**Rolling Knolls Landfill Superfund SITE**  
**FIELD CHANGE REQUEST (FCR) FORM**

DATE: 04/22/2015 (revised 05/19/2015)

FCR TITLE: Monitoring Well Location and Installation Method Modification

**Table 1**  
**Monitoring Well Locations Modification FCR 06**  
**Rolling Knolls Landfill Superfund Site**  
**Chatham, New Jersey**

FIGURE  
**3**

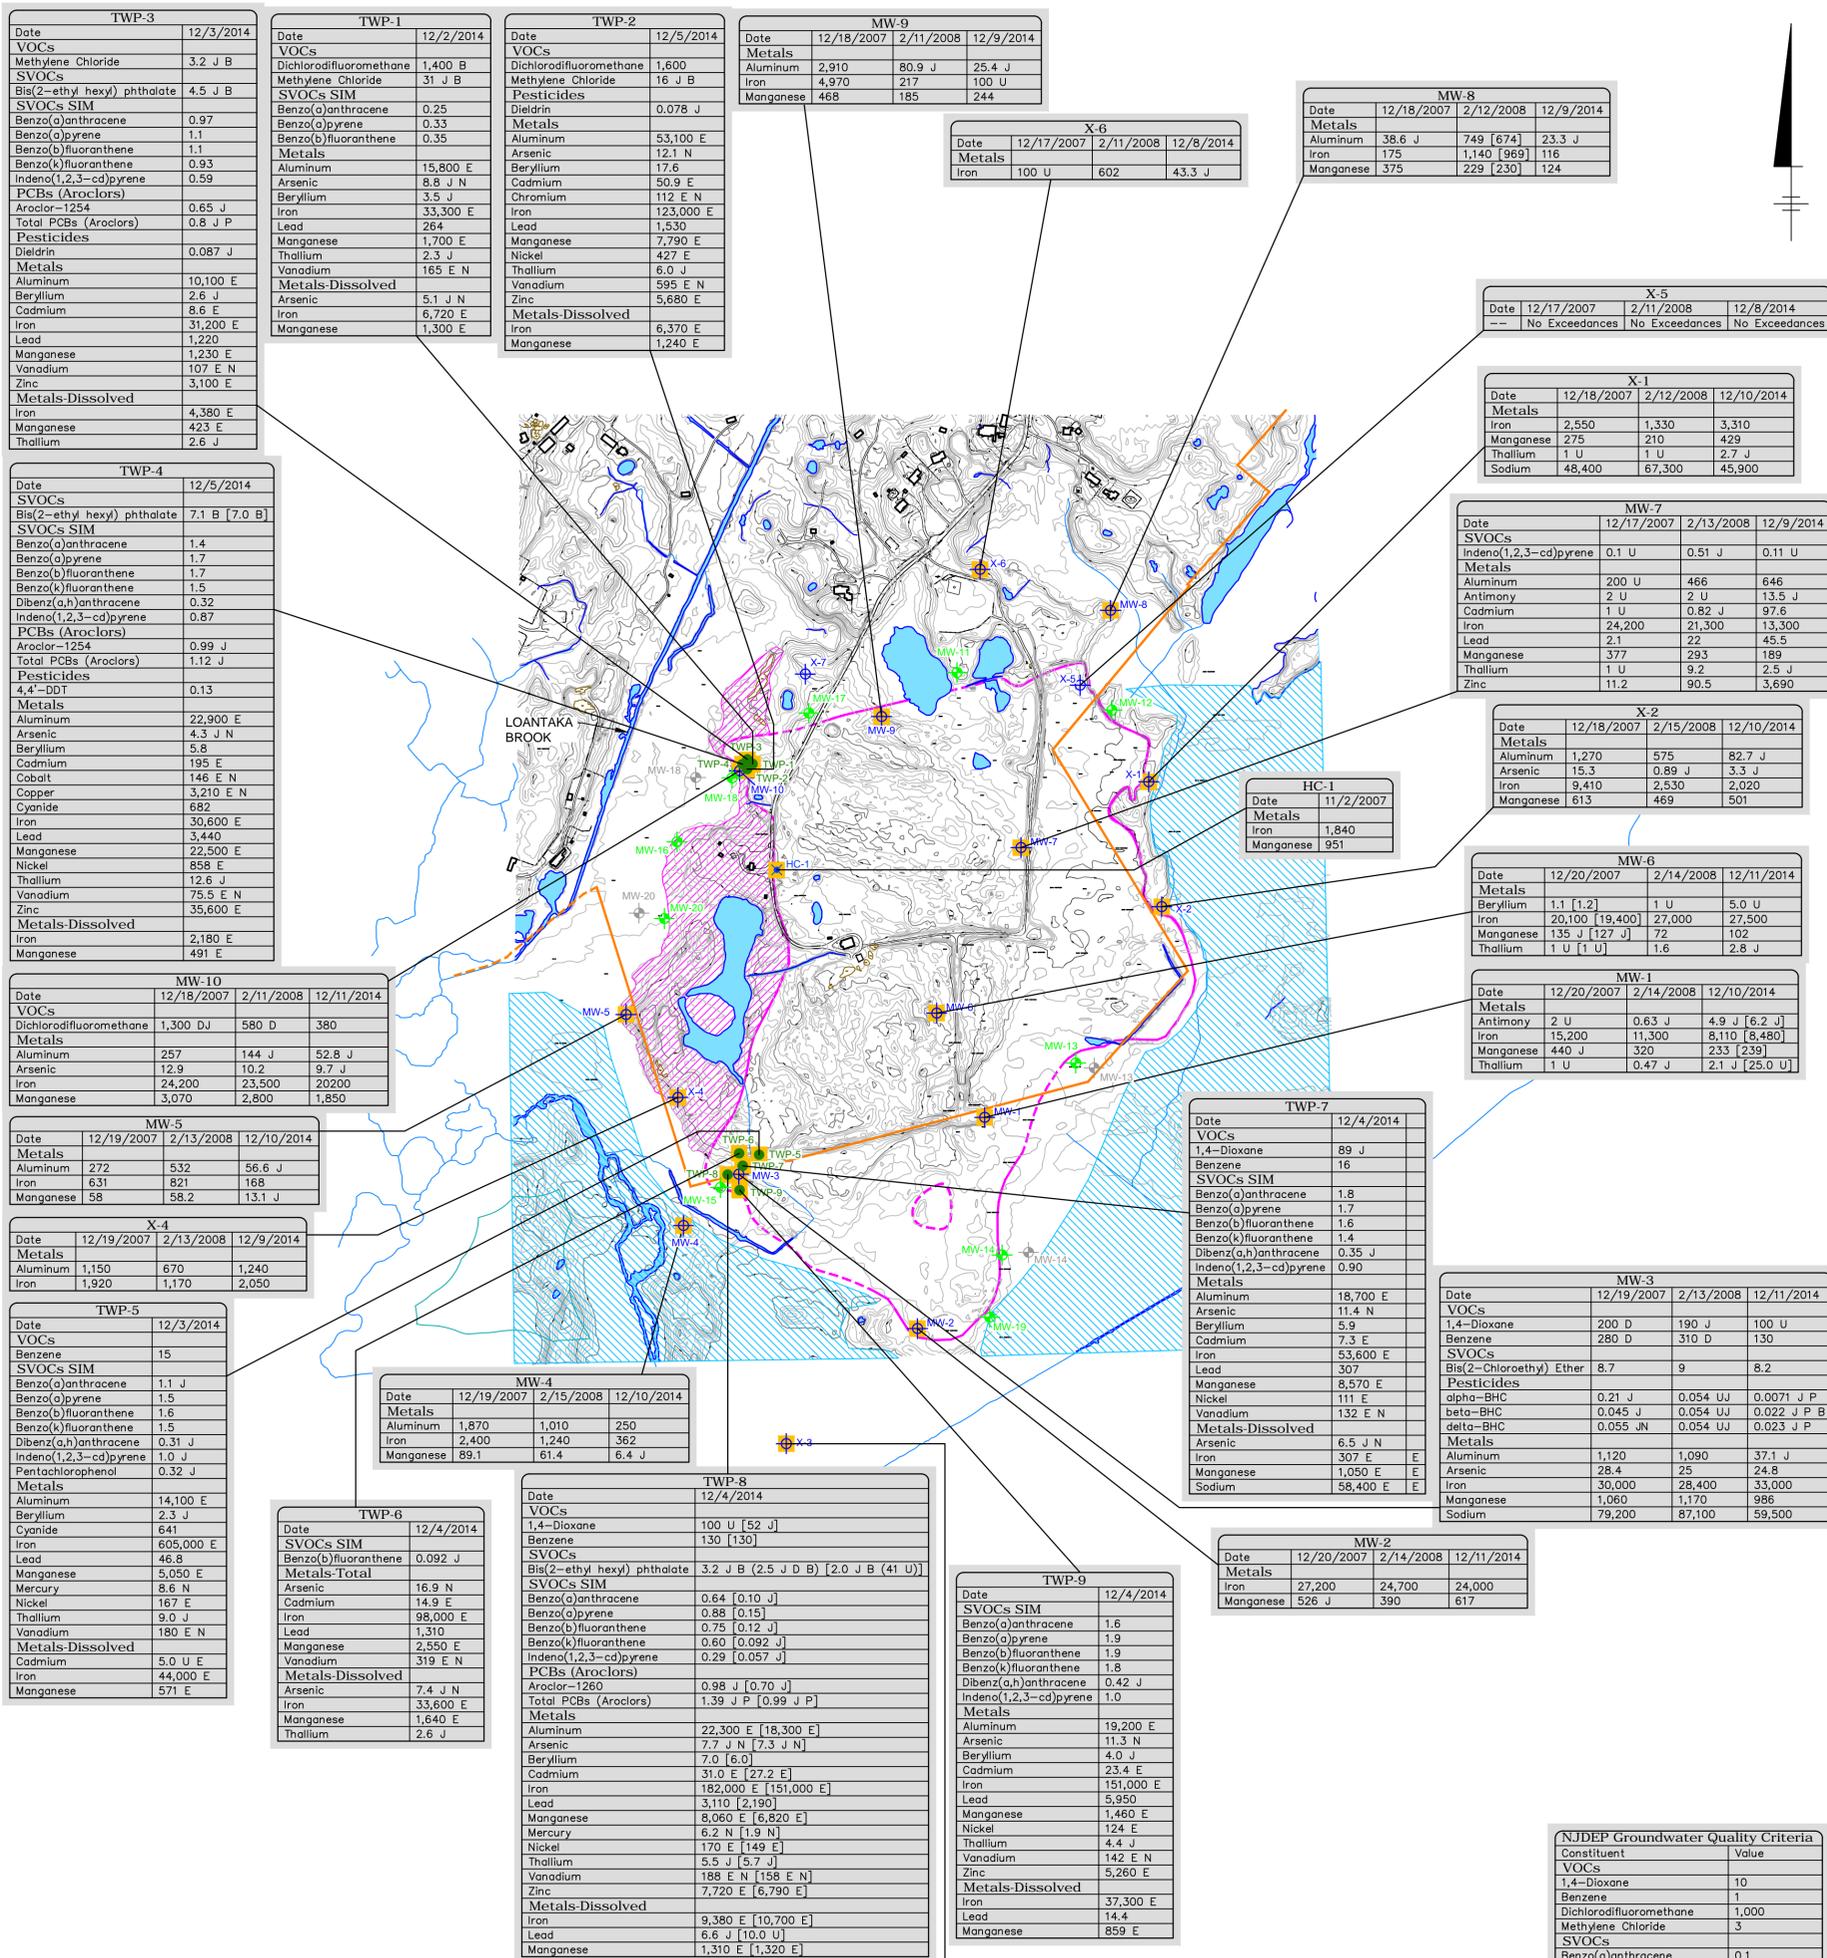
Prior to installation of the monitoring wells ARCADIS personnel and a USEPA representative inspected each proposed monitoring well location. Proposed locations for MW-13, MW-14, MW-18 and MW-20 were found to be in approximately 6 to 24 inches of standing water. These locations should be moved to areas with no standing water. The initial proposed and revised locations of these wells are included on the attached figure. The approximate distance each monitoring well will be moved compared to the location approved by USEPA on March 5, 2015 is included in Table 1 and described below.

Monitoring well MW-13 should be moved approximately 100 feet (ft) to the northwest. This location would likely shift the monitoring well to drier ground and still achieve the objective of characterizing constituent concentrations in groundwater downgradient of soil samples SS-157 and SS-158.

Monitoring well MW-14 should be moved approximately 140 ft to the west. This location would likely shift the monitoring well to drier ground and still achieve the objective of characterizing constituent concentrations in groundwater in the vicinity of soil samples SS-135, SS-136, and SS-137.

Monitoring well MW-18 should be moved approximately 200 ft to the east. This location would likely shift the monitoring well to drier ground and still achieve the objective of characterizing constituent concentrations in groundwater downgradient of monitoring well MW-10.

Monitoring well MW-20 should be moved approximately 140 ft to the east. This location would likely shift the monitoring well to drier ground and still achieve the objective of characterizing constituent concentrations in groundwater in the vicinity of soil samples POI-6, POI-14, SS-144, and SS-160.

<b>Well Number</b>	<b>Initial Proposed Location</b>	<b>Revised Proposed Location</b>	<b>Distance and Direction Moved</b>	<b>Rationale</b>
MW-13	Southeast landfill boundary, 100 feet southeast of soil sample SS-158	34 feet southwest of soil sample SS-158	100 feet northwest	Provides monitoring in vicinity of PCBs detected in soil samples SS-157 and SS-158.
MW-14	Southeast landfill boundary, 150 feet southeast of SS-136	Southeast of landfill boundary, 110 feet south of SS-136	140 feet west	Provides monitoring in the vicinity of PCBs detected in soil samples SS-135, SS-136, and SS-137.
MW-18	Northwest landfill boundary, 240 feet west of MW-10	Northeast landfill boundary, 60 feet southwest of MW-10	200 feet east	Characterize constituent concentrations in groundwater downgradient of monitoring well MW-10.
MW-20	Northwest landfill boundary, 300 feet west of POI-14	Northwest landfill boundary, 160 feet west of POI-16	140 feet east	Characterize constituent concentrations in groundwater in the vicinity of soil samples POI-6, POI-14, SS-144, and SS-160.
